DESIGN COMMISSION REGULAR VIDEO MEETING AGENDA

STAFF REPORT

DESIGN COMMISSION FINDINGS OF FACT AND CONCLUSIONS OF LAW

Project No.:	DSR21-012
Description:	A request for design review approval to renovate an existing gas station in the Town Center.
Applicant / Owner:	Brad Kaul (Kaul Design Architecture, PLLC) / Matt Randish
Site Address:	7833 SE 28th Street, Mercer Island, WA 98040, identified by King County Assessor's tax parcel number 5452300380.
Zoning District	Town Center (TC)
Staff Contact:	Ryan Harriman, EMPA, AICP – Planning Manager
Exhibits:	<ol style="list-style-type: none"> 1. Development Application, received on October 6, 2021 2. Notice of Application, dated January 24, 2022 3. Plan Set, received on December 21, 2021 4. Project Narrative, received on December 21, 2021 5. SEPA Checklist, dated March 5, 2021 (See SUB2 for SEP20-025) 6. Mitigated Determination of Nonsignificance, issued by the City of Mercer Island on September 27, 2021 7. Arborist Report prepared by Tree133 LLC, dated October 20, 2020 8. Transportation and Civil Engineering Trip Generation Report prepared by Heath and Associated, Inc, dated October 15, 2020 9. Study Session Feedback and Applicant Respons

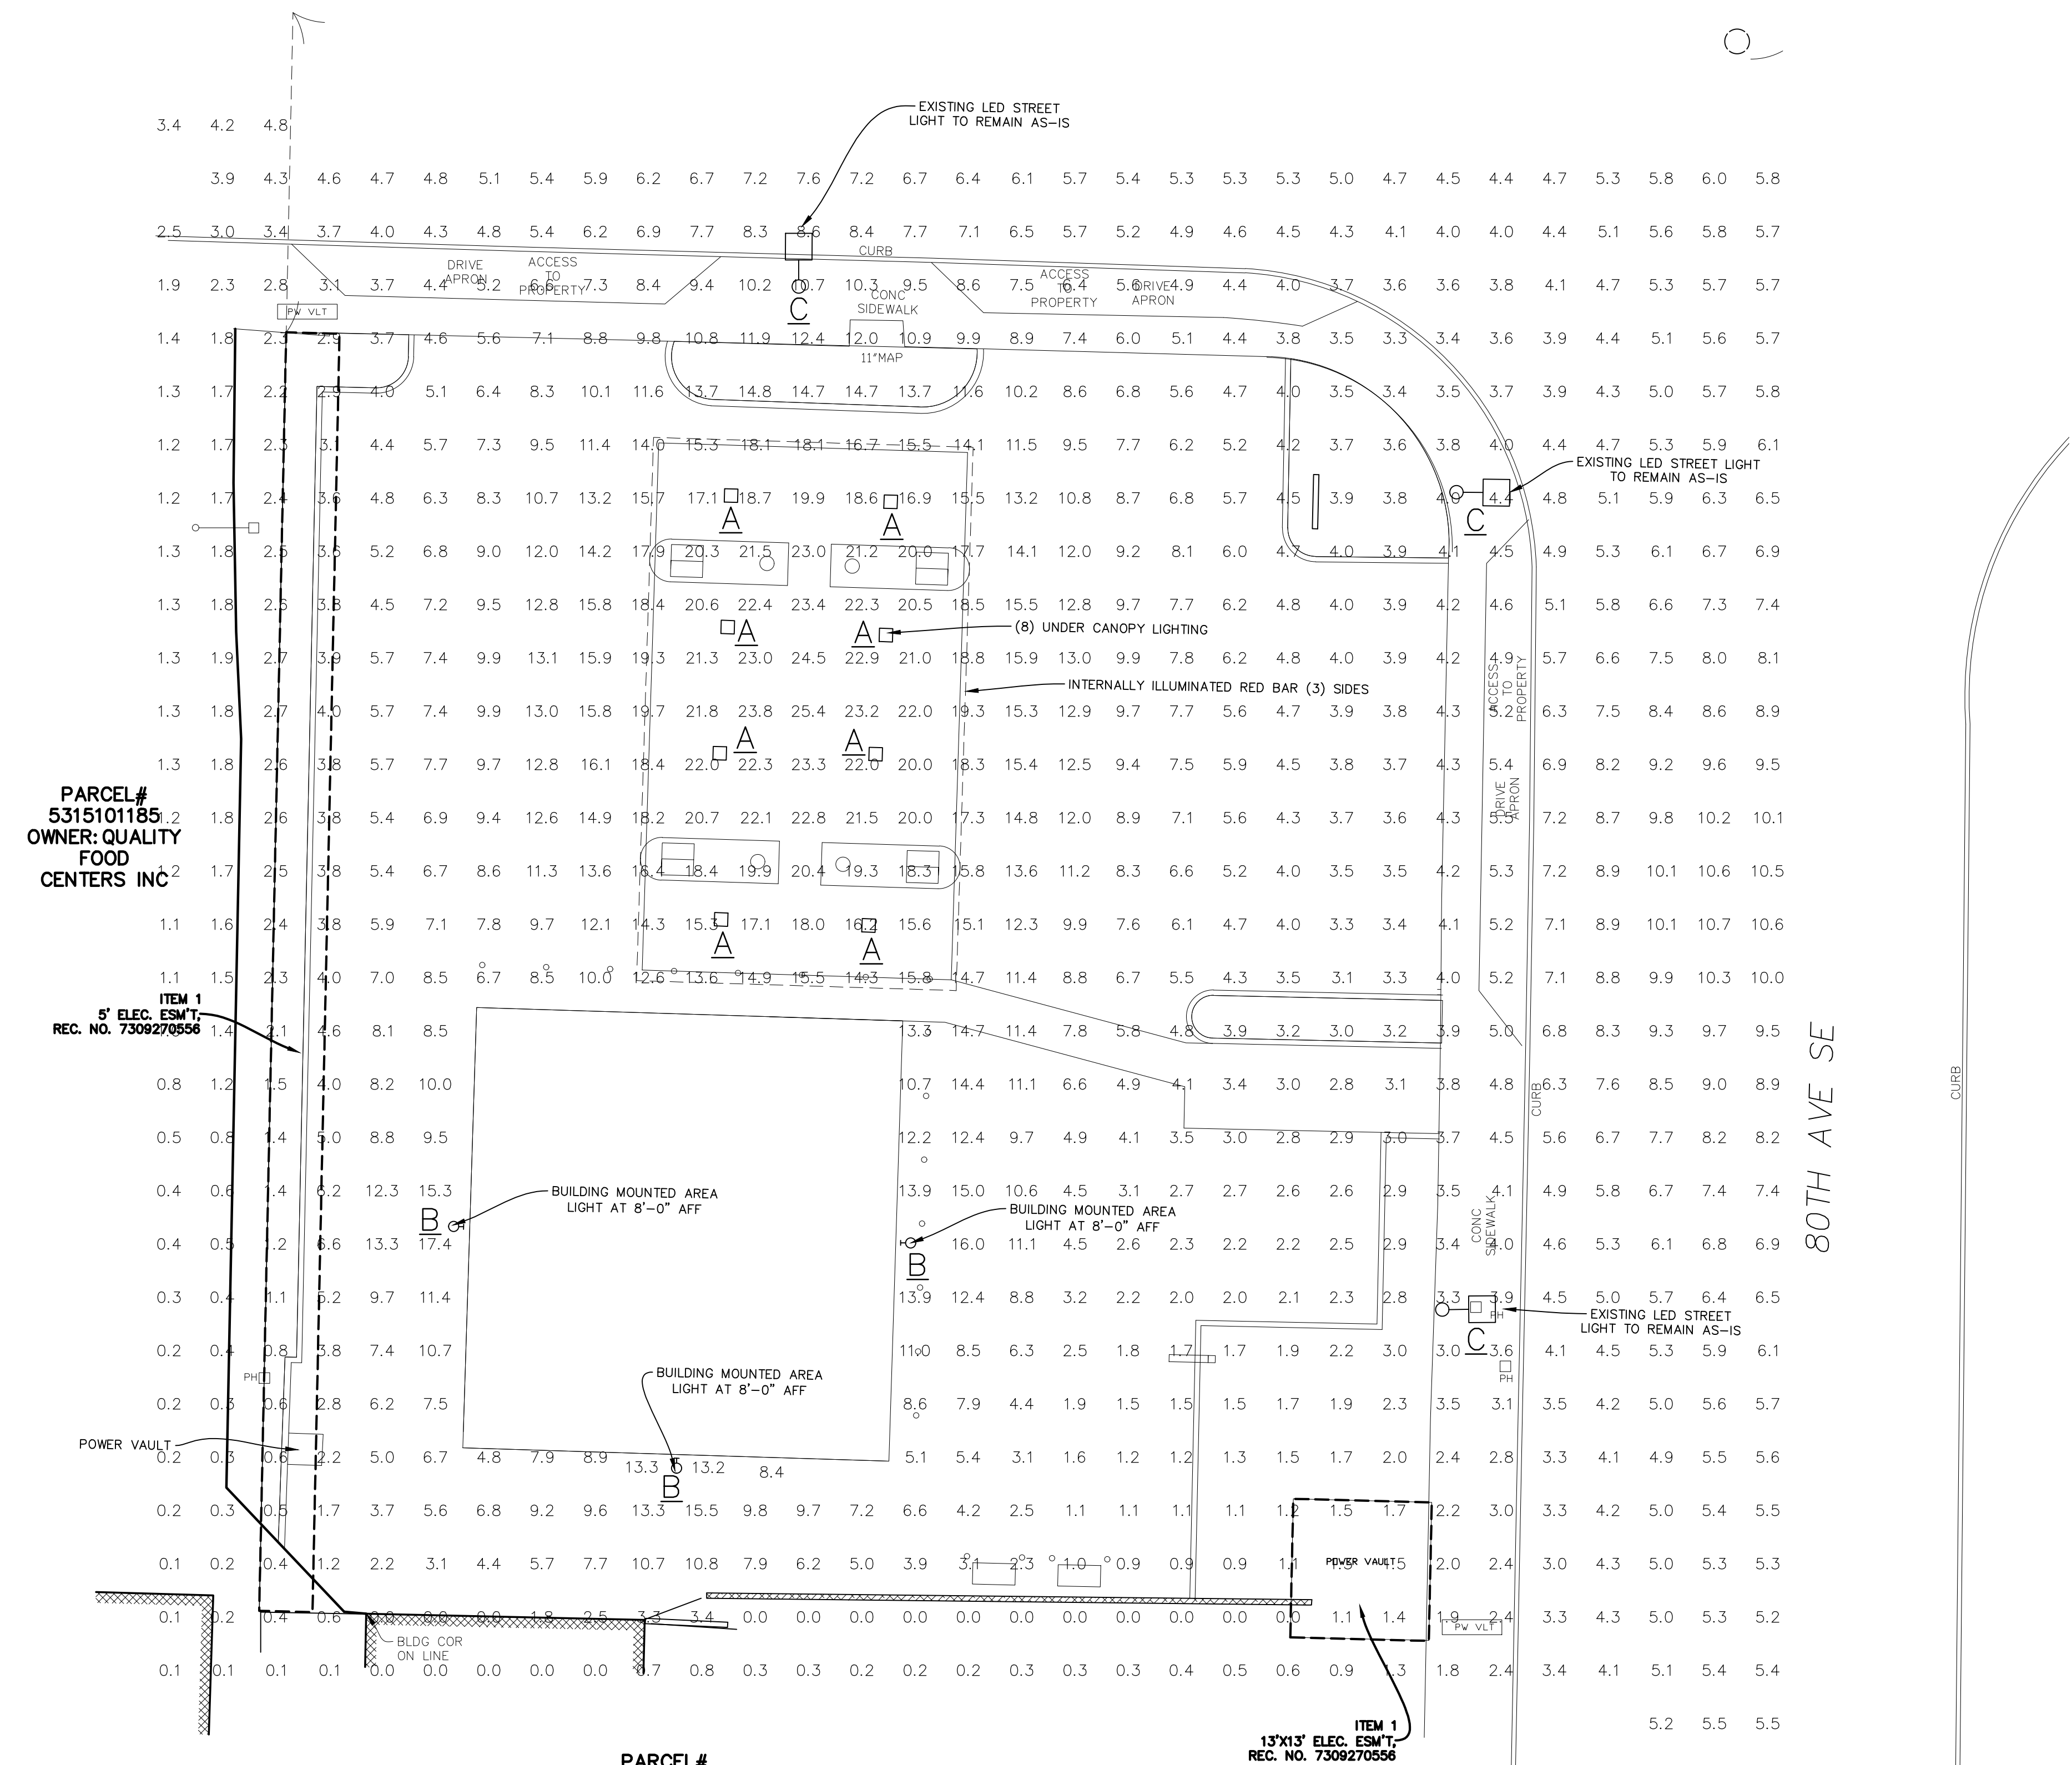
Staff Finding: Please refer to the lighting plan on **Page 11 of Exhibit 3**. The proposed development does not meet the definition of major new construction and most of the design elements in Chapter 19.11 MICC are not applicable. The existing lighting will remain similar to what is existing.
